NEW BEDFORD WATER WORKS

FOUNDATION PERMIT

No. **B-19-1821**

RE: TB-19-1821

PROPOSED SITE PLAN
SCALE: 1" = 20'

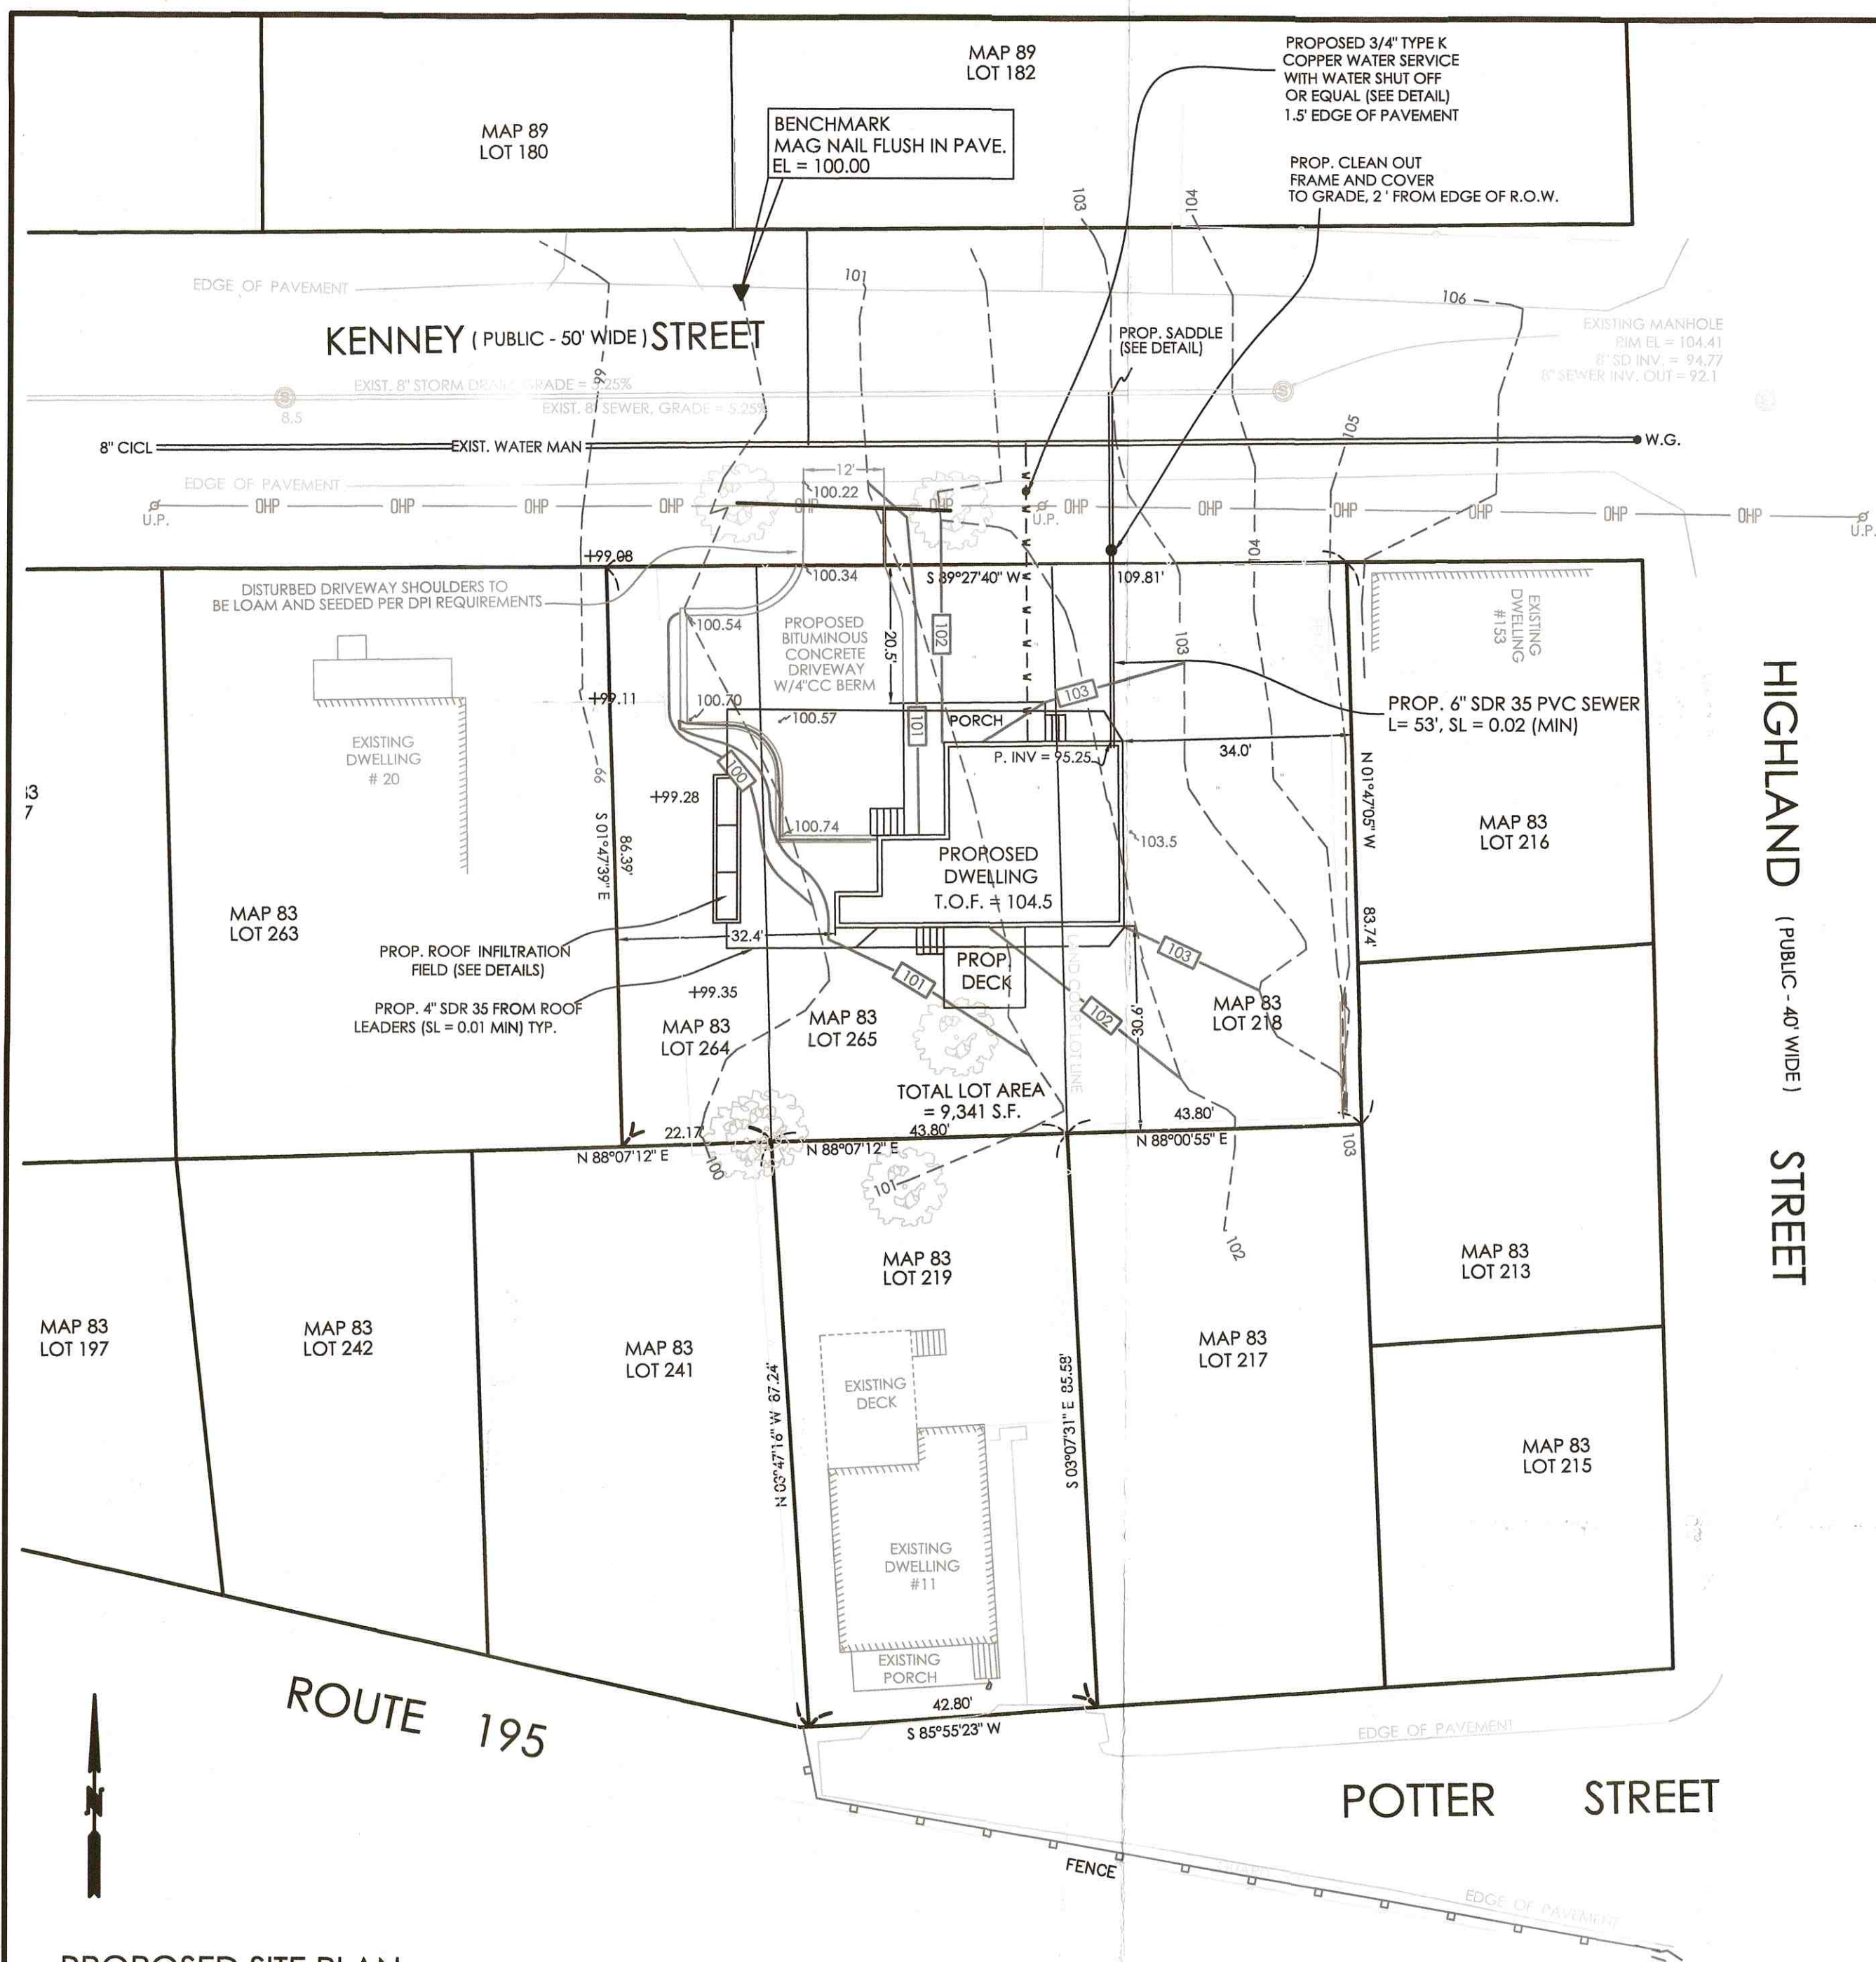
1.) The site plan submitted to D.P.I., titled: "Building Permit Plan, Ronald W.P. Sylvia, Assessors Map 83 Lot 264, 265, 218, Kenney Street, New Bedford, MA", dated 8/20/2019), as prepared by S&K Engineering, LLC and stamped/signed by Kevin J. Silva, P.E. (Civil), was not approved as the "final" site plan, and thus the above foundation permit is being "conditionally" approved by D.P.I., pending the following revisions to the plan:

a. The width of the proposed driveway apron within the City Layout must be adjusted. Per Manny Silva, the 18' driveway apron that is being proposed between the 2 existing City trees will not be allowed. The maximum width that will be allowed is 12' (centered between the 2 City trees). The plan must be updated accordingly. If the applicant requires the 18' width and moving the originally proposed location is not an option, they need to contact D.P.I. regarding the process/costs associated with the removal of the two City trees. If the applicant chooses to proceed with the tree removal, the plan must be updated with a note: "The owner (or their representative) must contact the City to arrange for the removal of the existing City trees in accordance to D.P.I.'s requirements."

b. The other revisions that need to be made include adding the "Record Owner" information on the plan; removing the Parcel One and Parcel Two notes (this is confusing, as there are 3 lots); labeling of each of the lots with its respective parcel i.d. and legal refs. (2 lots should Bk./Pg. and 1 lot has certificate #); updating of the legal refs. called out on the plan (the land transferred to new ownership back in January of this year, yet the submitted plan has a recent date); and, adding the driveway brow detail, or a note stating that the contractor will be required to grade and loam/seed the City Layout area abutting the driveway in accordance with D.P.I. requirements.

Once said site plan has been re-submitted and approved by D.P.I., it must be placed on file with Inspectional Services in the View Permit system. No D.P.I. permits will be issued for any of the proposed work until item 1 has been completed.
